FM Notification Report Serial Number 10-05

10CFR 21.21 (d)(3)(ii) Notification

Facility: PSE&G (Hope Creek)

Electronic Speed Switch (FM P/N 11916260)

Figure 1

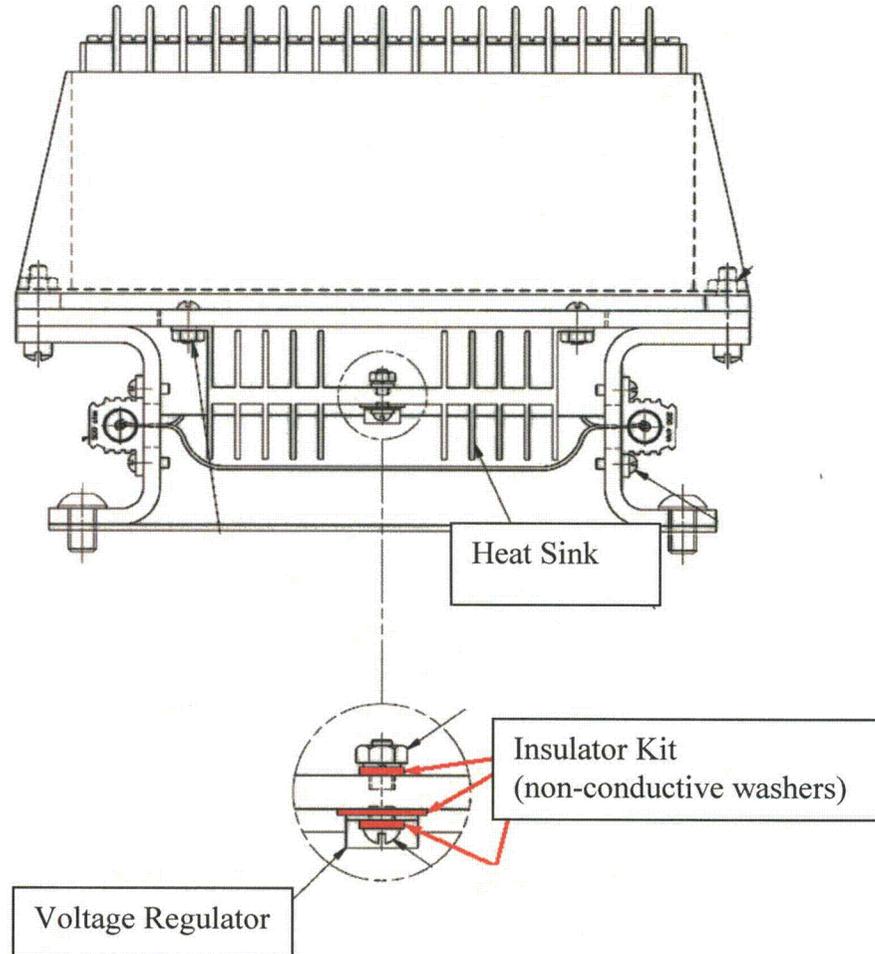
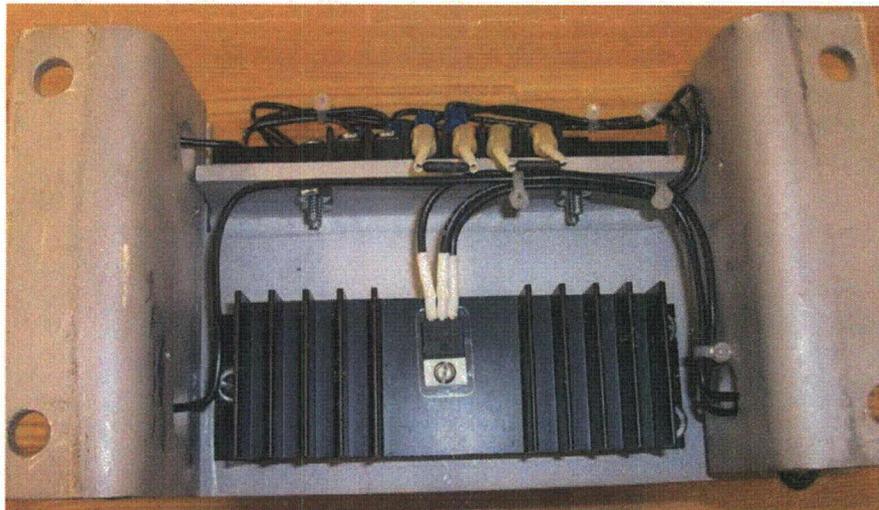
Fairbanks Morse (FM) evaluation has determined that a potential safety hazard existed for the original FM P/N 11916260 created from FM P/N P12620666 rev 0 that was delivered to Hope Creek. Subsequent to shipment to Hope Creek, additional testing found that when the speed switch assembly was mounted on a conductive surface, the voltage regulator grounded out the 24 vdc power through the heat sink preventing the speed switch from operating.

By adding an insulator kit, the speed switch circuit was isolated from ground and verified as functional. The FM initial design of the speed switch did not include the insulator kit (non-conductive washers) that would electrically isolate the voltage regulator from the heat sink and thus the metal mounting surface.

The one affected unit 11916260 created from P12620666 rev 0 was recalled and modified by adding an insulator kit (item 23) between the voltage regulator (item 8) and the heat sink (item 7) as shown in Figure 1. The design records have been updated accordingly. The assembly drawing, P12620666, and engineering bill of material have been updated. In addition the inspection plans for this part have been updated to include a circuit isolation check to confirm that the case of the voltage regulator is electrically isolated from the aluminum brackets. The inspectors have been trained in how to perform these checks.
